**DEVELOPMENT APPLICATION DA 2020/0816  
23-33 BASSETT STREET MONA VALE  
PROPOSED RESIDENTIAL CARE FACILITY UNDER SEPP HOUSING  
FOR SENIORS**

This document is a submission by way of objection to Development Application 2020/0816 (the 'development application') relation to Nos 23 - 33 Bassett Street Mona Vale (the 'subject property').

**Figure 1-** North elevation showing west boundary of site and relationship with adjoining cottage style development

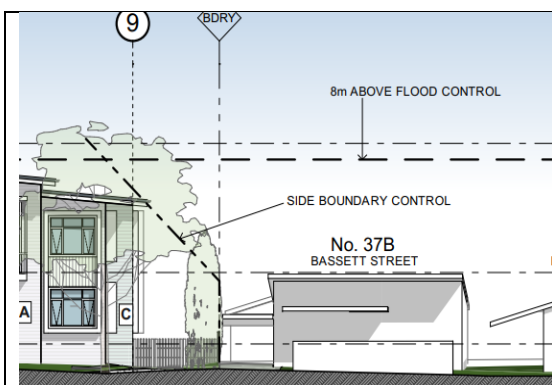
This site is not in a medium density residential zone nor is the property located in a mixed use commercial type environment. The fact that the site is zoned for 'low density residential' purposes should be instructive to the applicant as far as the development proposal is concerned. This is especially the case where low density residential extant development is to be replaced by a high density facility (over the eastern part of the land). We contend that the architect has failed to take into account the reasonable expectations of adjoining land owners and occupiers in this regard. Figures 1 and 2 below show the relationship between the proposal and adjoining development to the east and west (source Gartner Trovato Architects). In our opinion the separation between the built elements in Figure 1 is not acceptable.

In our view the building should be broken into at least two built elements crossways, so that some respect can be paid to the built form of existing cottages in other parts of this streetscape (with their narrow frontages), the relevant low density zone and the PDCP character statement suggesting that vegetation should be integrated with development. In this case the reduced street setbacks will not allow for sufficient planting to soften this bulky and very lengthy facade.

**Figure 2-** North elevation showing east boundary of site and relationship with adjoining cottage style development

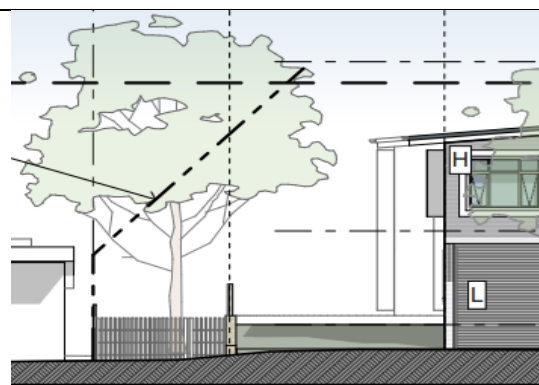
Below is an extract from the drawings by Gartner Trovato Architects, showing the length of proposed building (around 95m total), when viewed from Bassett Street. The long, unarticulated length of this facade, is completely uncharacteristic of adjoining and nearby development. As Council will be aware the existing building is at odds with the nearby building character. When this bulk is extended for a further distance along Bassett Street, a significant change in the dominant character of the southern side of Bassett Street will result. In our minds this is particularly undesirable.
